Project Title:
NORTH MANCHESTER GENERAL HOSPITAL

Drawing Title:
LASER CUT PANELS & EXP. MESH FACADE
TYPICAL BAY EXPANDED MESH PLANS

Document Reference:
EX31618-01C-D-P01

TYPICAL BAY EXPANDED MESH 1st FLOOR PLAN

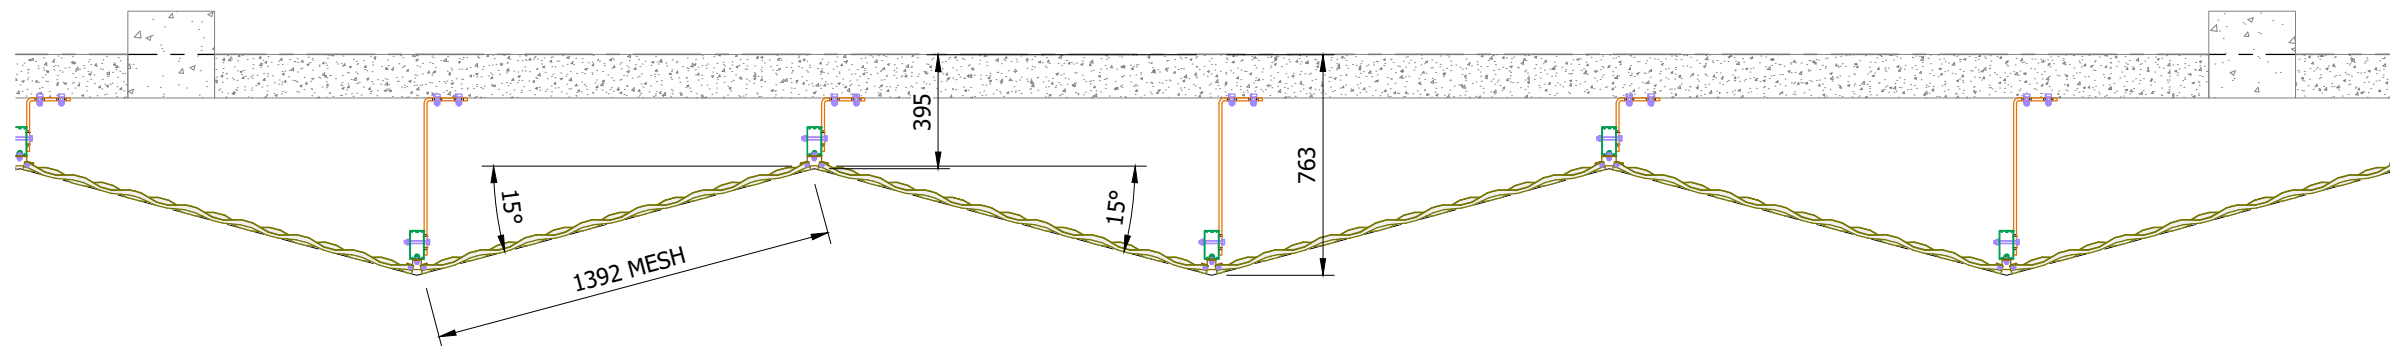
CLIENT NOTE: FLASHINGS WILL BE FITTED WITH 5-10mm TOLERANCE GAP BETWEEN DUE TO ALLOWANCE OF SITE TOLERANCE
